**TECHNICAL MEMORANDUM**

**DATE:** August 31, 2011 **PROJECT:** 1362.01  
**TO:** Wayne Costa, TOWN OF FLORENCE  
**FROM:** Michele Robertson and Dennis Hall  
**MONTGOMERY & ASSOCIATES**

**SUBJECT: REVIEW OF CURIS RESOURCES (ARIZONA) INC. APPLICATIONS  
 PZC-32-11-MGPA and PZC-33-11-MGPA FOR GENERAL PLAN  
 AMENDMENTS FOR FLORENCE COPPER PROJECT, FLORENCE,  
 ARIZONA**

FIGURE 5. RECHARGE AND PRODUCTION WELL LOCATIONS

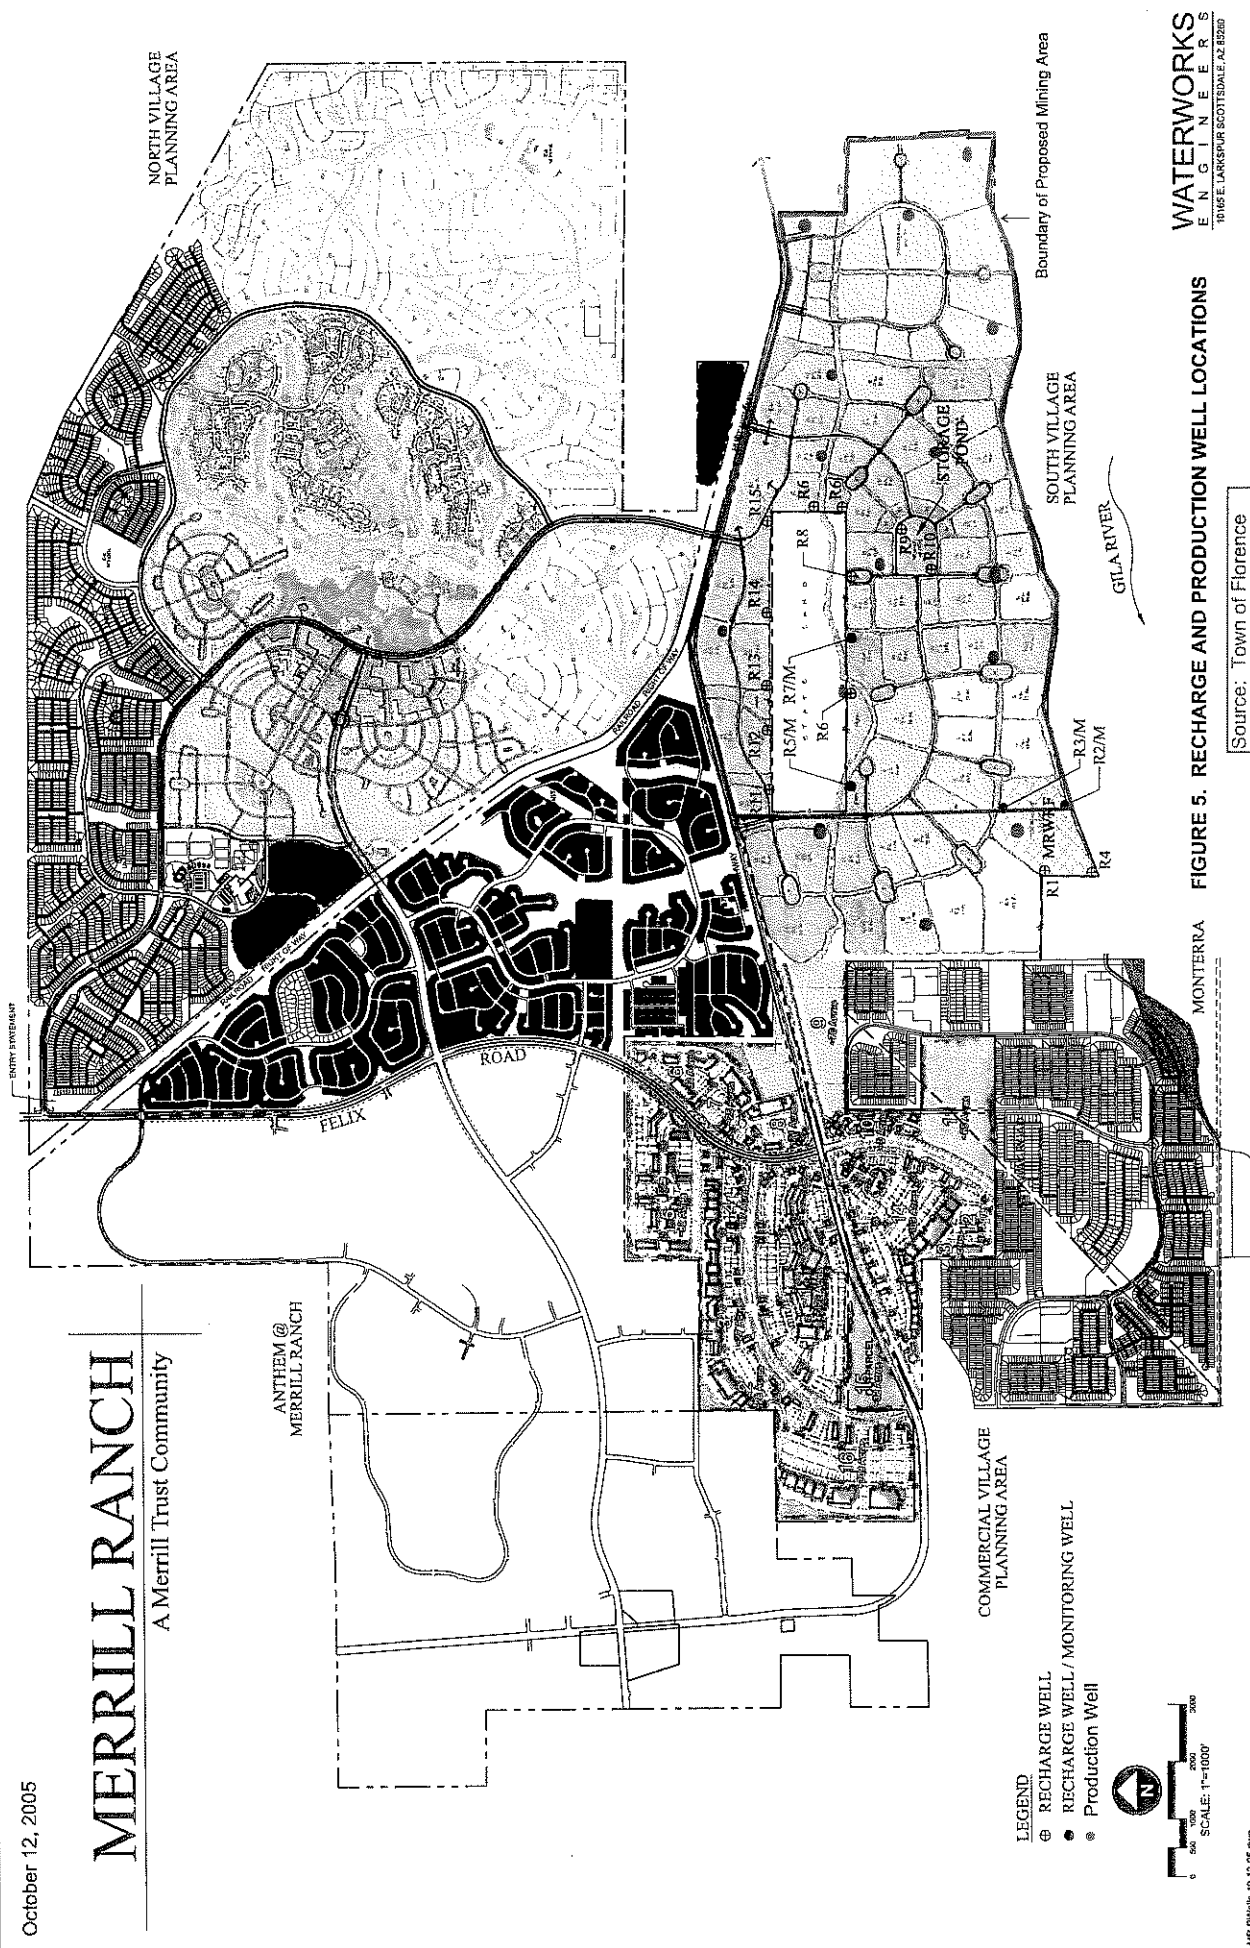
Two potential locations were provided by TOF for the potential future water reclamation facility for Merrill Ranch Master Planned Community. One of these locations has two options to provide for recharge of reclaimed water that would be generated at the proposed Merrill Ranch Water Reclamation Plant (**Figure 5**): one within the Curis property; and one adjacent to the Curis property. The option within the Curis property includes potential installation of vadose zone recharge wells around the boundary of the State Trust Land parcel. The State Trust land is included within the area that Curis proposes for ISCR operations. As a result, TOF is considering other locations for these recharge wells. If the ISCR operations proceed, recharge in this area would not be appropriate and the recharge wells would need to be relocated. Post-mining installation and use of vadose zone recharge wells within the mining area may potentially be acceptable following closure of the ISCR operations, but further hydrogeologic and groundwater quality evaluations would be required at that time prior to proceeding. The option for locating the water reclamation plant adjacent to the Curis property (southwest corner) also includes potential installation of vadose zone recharge wells. Additional potential production wells are shown in this area on **Figure 6**. If the ISCR operations proceed, recharge in this area may be appropriate, as the recharge operations may enhance the hydraulic containment of the ISCR leach solution; however, we recommend further hydrogeologic evaluations be conducted prior to proceeding with this option.

The FCP should have no impact on the ability of Florence to continue to maintain compliance with the Safe Drinking Water program. However, if Florence intends to install potable supply wells on the west side of the Curis property (**Figures 5 and 6**), it is suggested that the potential impact of wells in that location be incorporated into the groundwater model of the Curis ISCR impacts.
